NASA AREA OF INVESTIGATION 14
INTERIM CORRECTIVE ACTION MEASURES
WORK PLAN

**NASA Ames Research Center
Moffett Field, CA**

October 2013

JOB ORDER NO. AOI 14 – 2013b
COMMENTS BY Joe Lukas, ERT Corporation	CODE JQ	PHONE 650-604-2057	DATE October 29, 2013
PROJECT TITLE AND LOCATION Environmental Protection Agency (EPA), Region IX, Comments on the “Draft AOI 14 Interim Corrective Action Work Plan, NASA Ames Research Center, Moffett Field, submitted June 19, 2013

Figure 5
Navy Site 25 Historical PCB Analytical Results

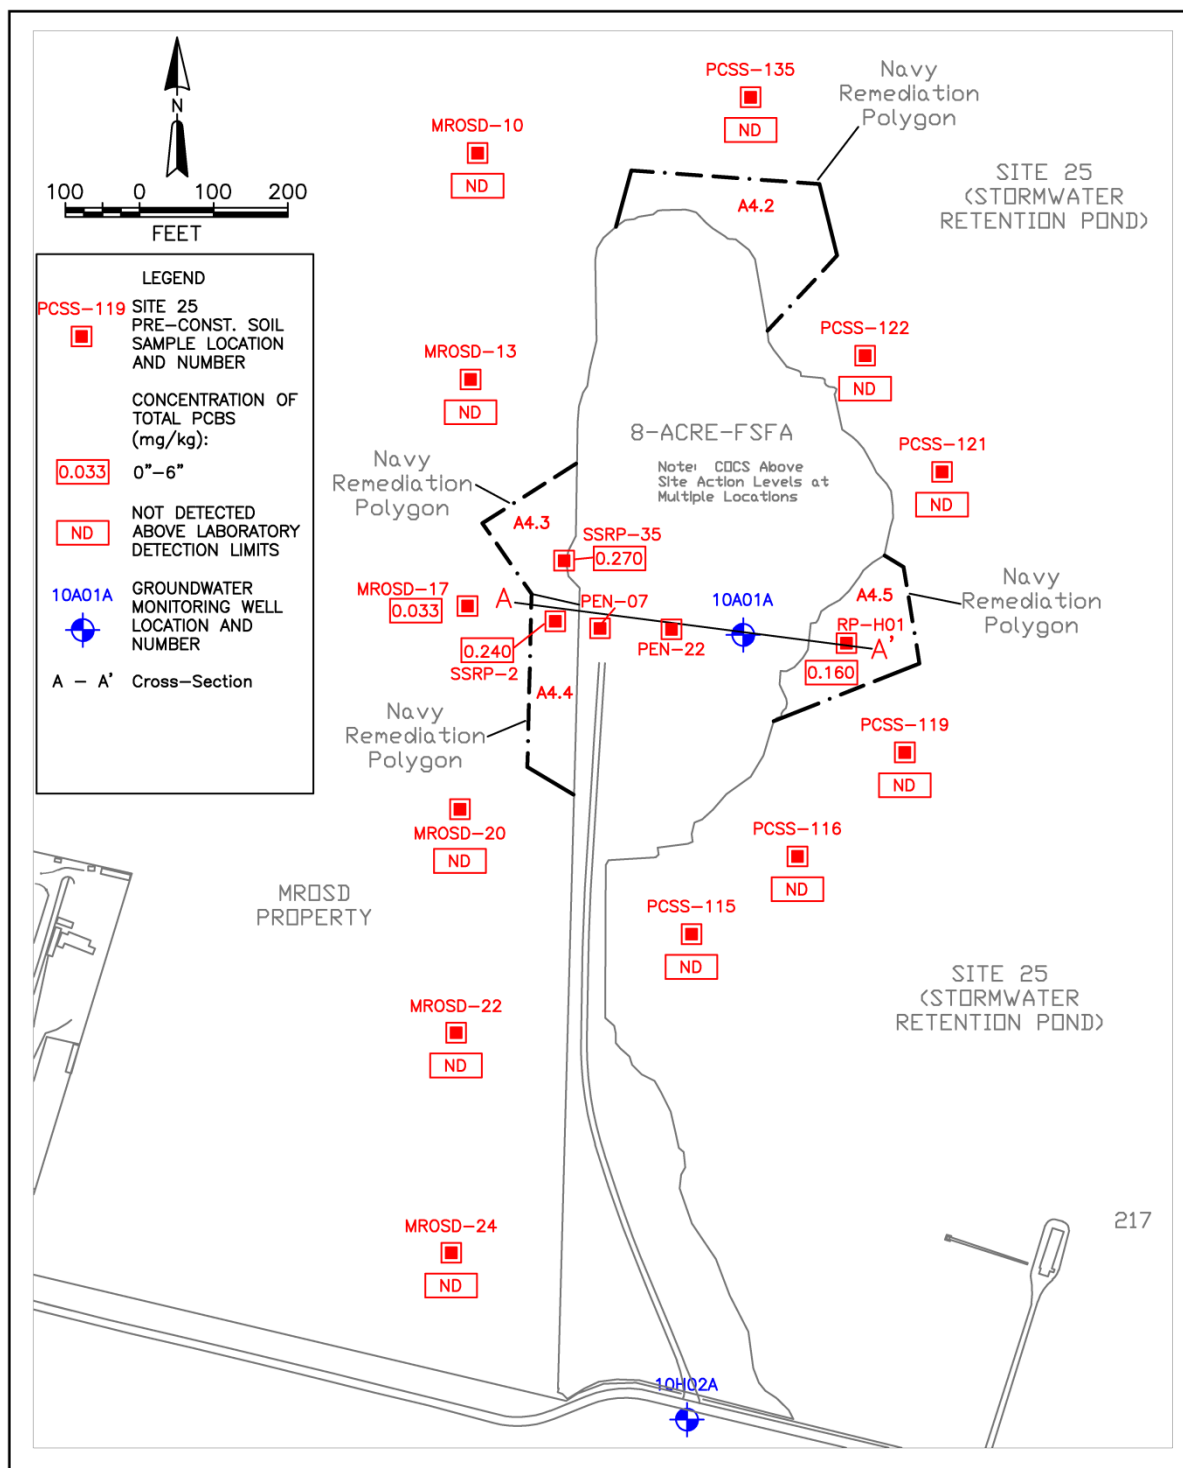
3. Figure 4: *Please include the names of the polygons that have been remediated by the Navy in the figure.*

- WP Figure 4 (renamed Figure 5) has been revised to include names of Navy remediated polygons.

Figure 7
AOI 14 Lithologic Cross-Section A-A'
(see Figure 5 for A-A' location)

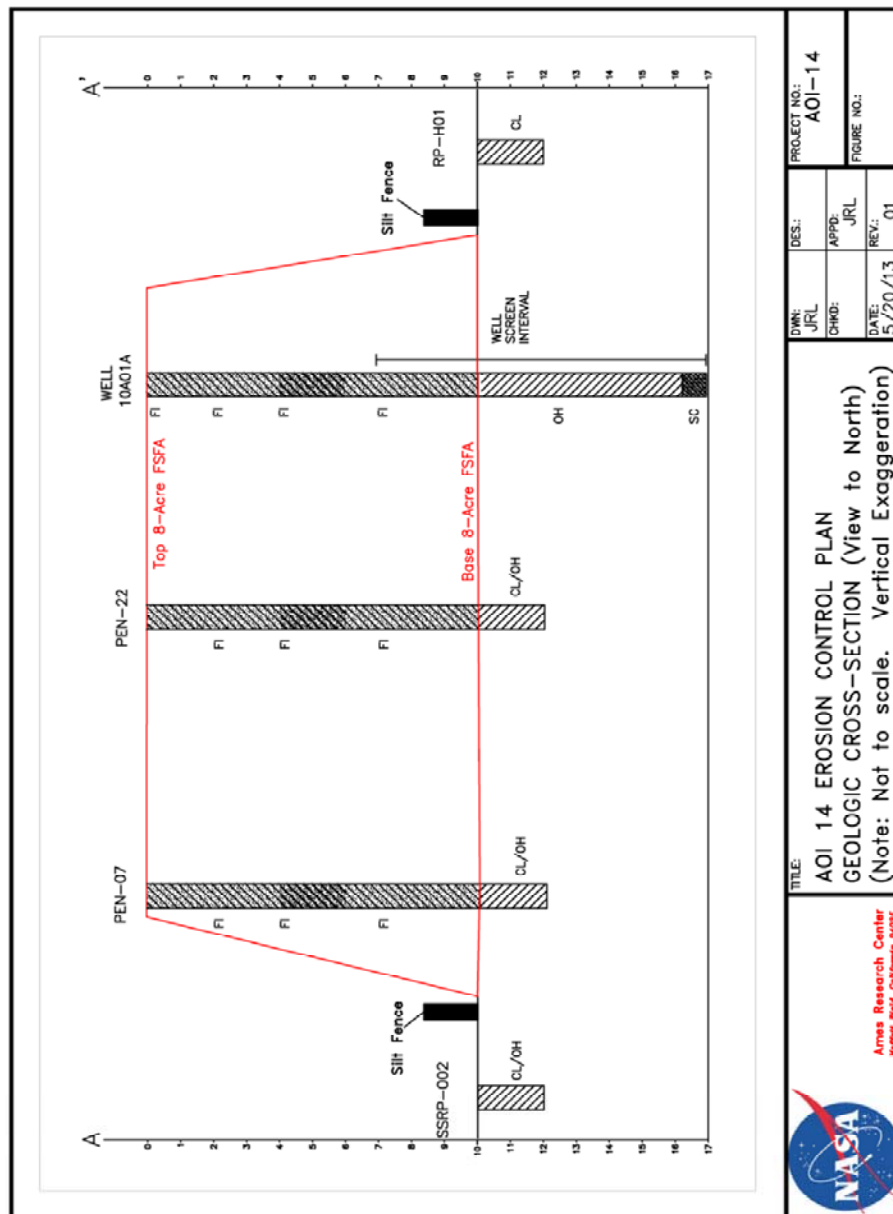
5. Figure 5: *The figure includes some unexplained abbreviations. Please include a key or notes explaining them. In addition, please label each of the borings on the cross section; three of the borings have no identifying number.*

Note: FL = Fill material; CL = Clay; OH = Highly Organic Clay; SC = poorly sorted sand.

- Figure 5 (now Figure 6) footnotes will be included on the figure to explain standard soil classification abbreviations included on the cross-section.
- The borings on the cross-section are representative of the 8-acre FSFA fill materials (FL) and underlying native clay (CL) sediment encountered in all borings. Borings located immediately adjacent to the cross-section line were utilized in the generation of this figure and include PEN-07 and PEN-22.

ITSI Gilbane Silt Fence Design Drawings

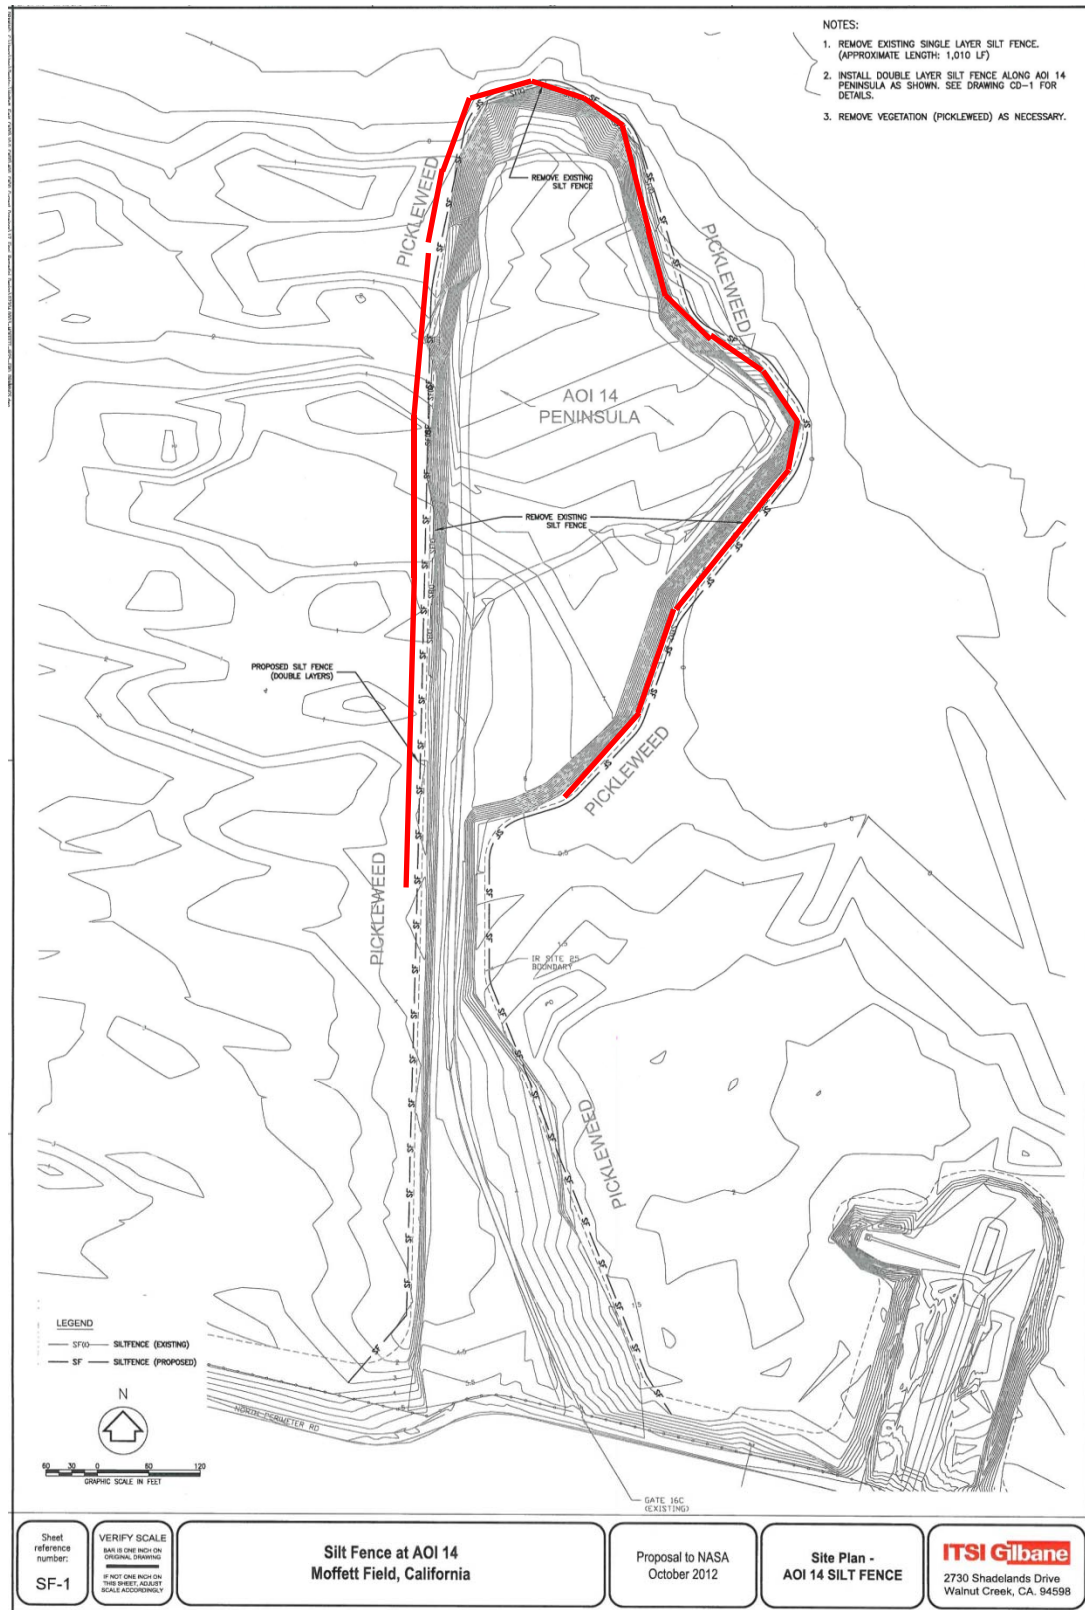
17. Attachment 2, Sheet Reference CD-1: *Sheet Reference CD-1 notes that the setback dimensions for the silt fencing will vary to fit site conditions. A 3'0" set back is shown in the figure. Please clarify if this is a maximum or minimum set back.*

Note 1: The 3'0" set back specified in Sheet Reference CD-1, Note #4, is the proposed maximum silt fence setback.

- WP text and Attachment 2 cover page will be revised to indicate that 3'0" is the proposed maximum silt fence setback, depending on surface composition (i.e.; demolition rubble interference).
